水務署
Water Supplies Department

**Approval of "DORNBRACHT" Sensor Mixer
(General Acceptance No. C20210979)**

13.715.705.XX + 42.765.970.90 +35.740.970.90

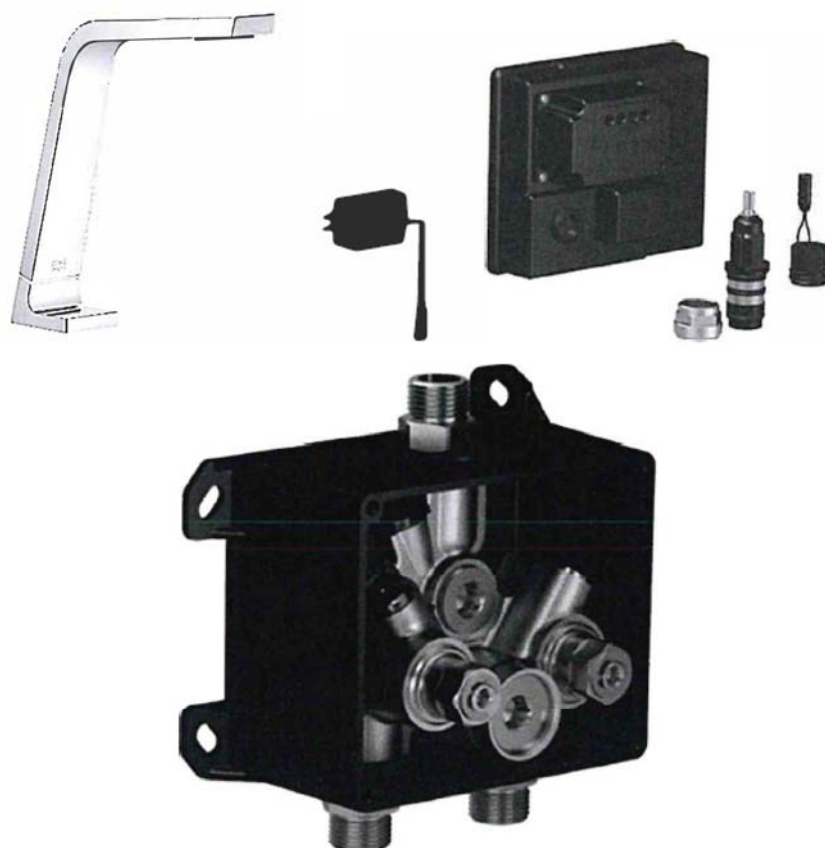
This Authority hereby permits the use of the above fitting in fresh water plumbing systems subject to full adherence to Waterworks installation requirements. In particular, you are required to draw your customers' attention to the following requirement-

"The cold water supply to the fitting shall be drawn from the same source that supplies the hot water apparatus so as to provide a balanced pressure and to obviate the risk of scalding in the event of a restriction or failure in the water supply."

"A stop cock or gate valve must be installed at the upstream of the fitting for manual isolation of water supply." AND

"The main voltage operated sensor valve should comply with the electricity safety regulation for applications in bathroom, toilet etc."
